Docket Item #7
BAR CASE # 2008-0179

BAR Meeting
October 22, 2008

ISSUE: Alterations

LOCATION: 1124 Princess Street

Figure 5. Existing front (north) elevation.

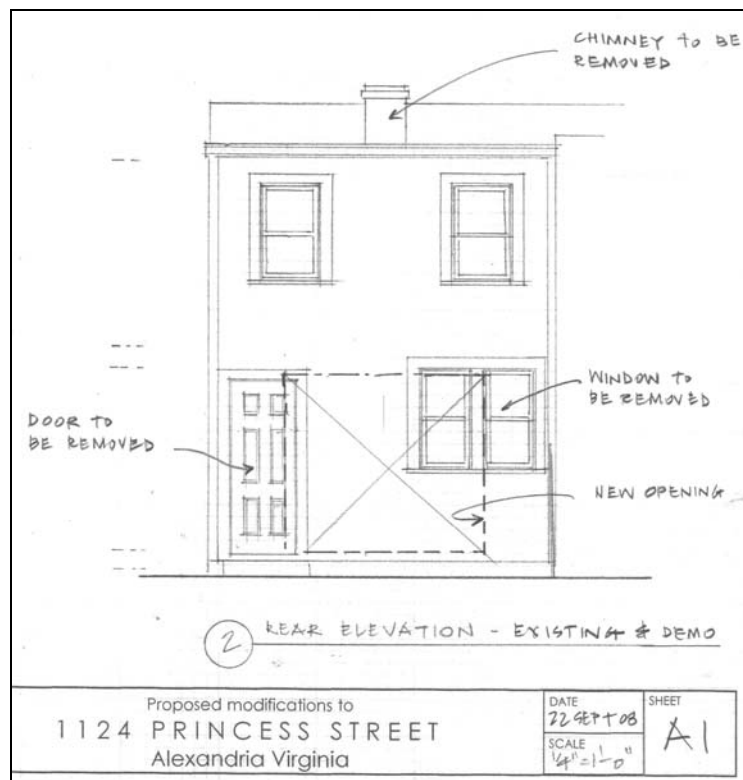
1. That the applicant eliminate the proposed bracketed canopy at the front door;
2. That the chimney be retained *in situ*;
3. That the applicant work with Staff for final approval of the proposed window and doors; and,

On the front (north) elevation, Staff has concerns regarding the proposed bracketed canopy over the front door. Staff notes that this rowhouse is one of a series of four rowhouses constructed circa 1890. As constructed, the four rowhouses had minimal ornamentation, with the only ornamentation being the cornice with brackets that still remain on all four units. While Staff acknowledges that this rowhouse, as well as the others in the series, have undergone alterations over time, all remain without a pediment or canopy at the front entrance. Staff finds that the proposed bracketed canopy disrupts the architectural style and rhythm of this series of rowhouses as it results in a higher style appearance than what is historically appropriate..

Figure 6. Existing rear (south) addition and proposed demolition.

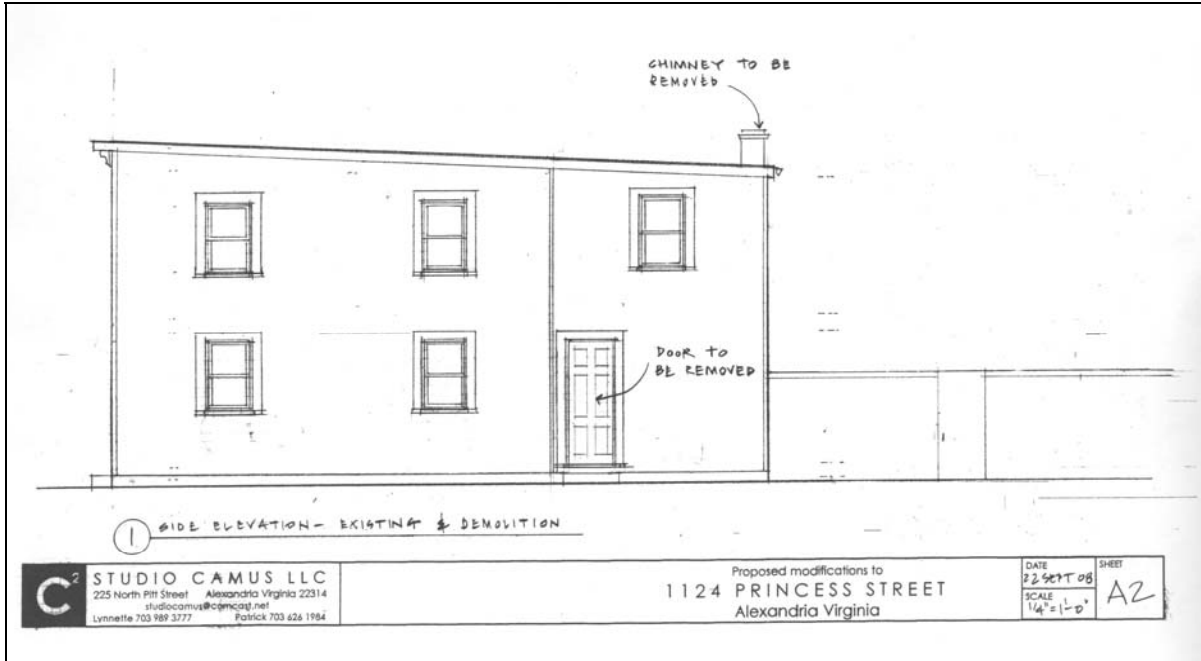
On the rear (south) elevation, Staff notes that the proposed demolition and alterations on the first floor will be partially visible from Fayette Street. Staff notes that this portion of the house is not original to the building and that the existing window and door configuration is likely not historic. Staff finds that the proposed wood French doors with a strong cornice are appropriate in this less visible location.

The *Design Guidelines* note that “existing chimneys should be maintained *in situ* and not removed without a compelling reason and substantial justification.” In speaking with the applicant, the reason for the removal is to accommodate internal changes. Staff does not find a compelling reason for removal of the exterior chimney at a highly visible location.

Figure 10. Proposed side (west) elevation and pergola details.

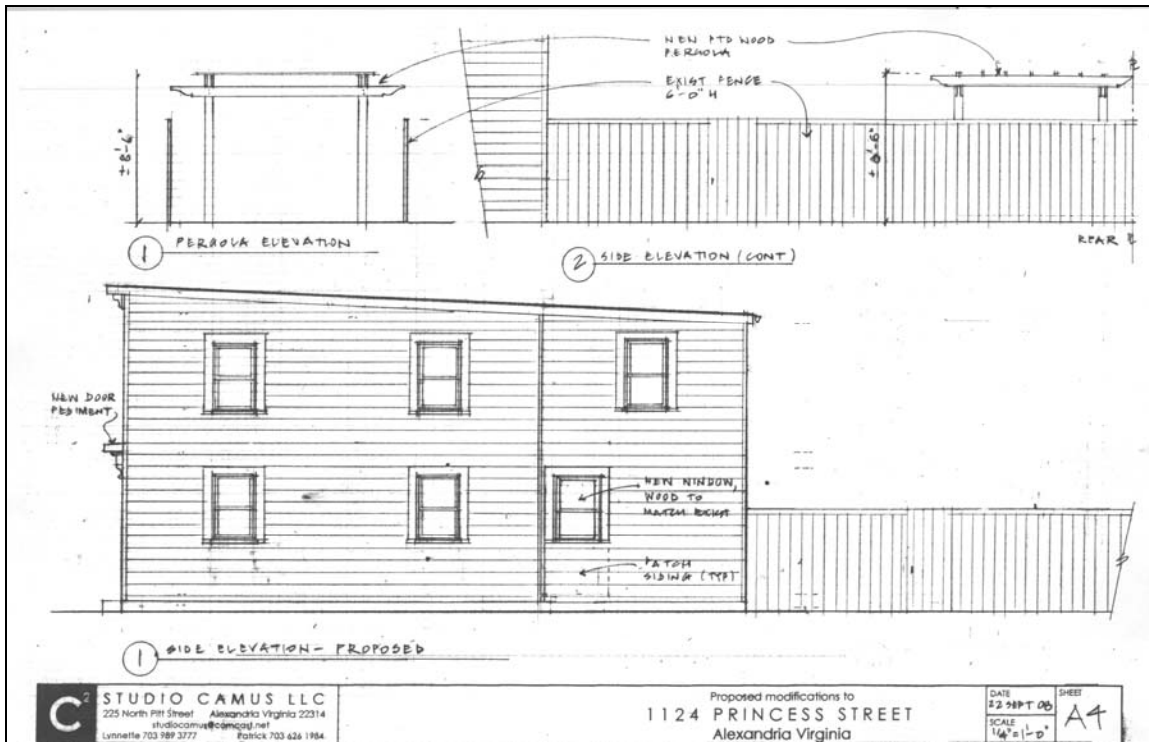
The *Design Guidelines* advise that “free-standing accessory structures should complement, not compete with, the architecture of the main building” and that “the materials of accessory structures should follow the historic usage of materials.” Staff finds that proposed painted wood pergola and location are appropriate.

Staff finds that the removal of the non-historic door is acceptable. Although a side elevation generally has an entrance to the street, Staff finds that the replacement of the door with a window is acceptable. The applicant notes that the new window will be a one-over-one, double-hung, double-insulated wood window, and will match the existing windows. This alteration will require the installation of siding under the window, to match the existing siding. Staff finds this alteration to be compatible with the *Design Guidelines*.
